### FAUQUIER COUNTY TECHNICAL REVIEW

# APPLICATION FOR CO-LOCATION SE02-M-15 UPPERVILLE VOLUNTEER FIRE COMPANY-SPRINT (ATC # 1007-44)

### Submitted By:

## February 11, 2002

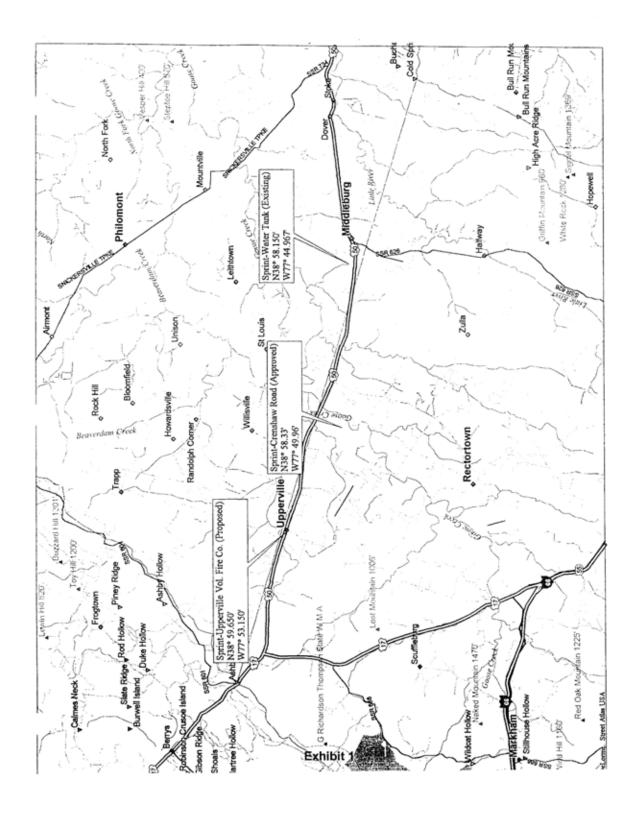
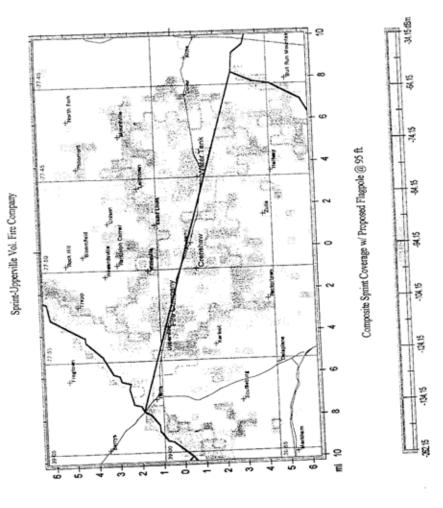
Sprint contends that an antenna height of 95 feet is needed in order to provide contiguous coverage with its existing and planned network of sites. Several scenarios were analyzed utilizing a combination of existing and proposed structures. Exhibit 2 shows the composite coverage of Sprint's Middleburg, Crenshaw, and UVFC site at a rad center elevation of 95 feet. Exhibit 3 shows the composite coverage of the Middleburg, Crenshaw, and UVFC site at a rad center elevation of 80 feet. Areas shaded in green and yellow (minimum –89 dBm) represent acceptable coverage with the areas in green representing the strongest communication back to the tower. Areas shaded gray represent "spotty" or unreliable coverage.

Projected coverage in the corridor is relatively unaffected at a rad center elevation of 80 feet compared with the proposed location of 95 feet. Sprint would be able to maintain connectivity with its planned and existing sites to the east. There is a nominal decrease in coverage area to the west. It should be noted that there are no known proposed Sprint sites west of Upperville to

which this site would connect. Any signal loss to the west could be compensated for by strategic placement of any future planned site in the corridor west of UVFC.

This analysis considered the RF requirements of the applicant without consideration to UVFC's pending application for a building permit. Based upon Sprint's existing and planned network of sites in the corridor, an 80-foot installation would provide adequate coverage and sufficiently achieve Sprint's coverage objectives as expressed.
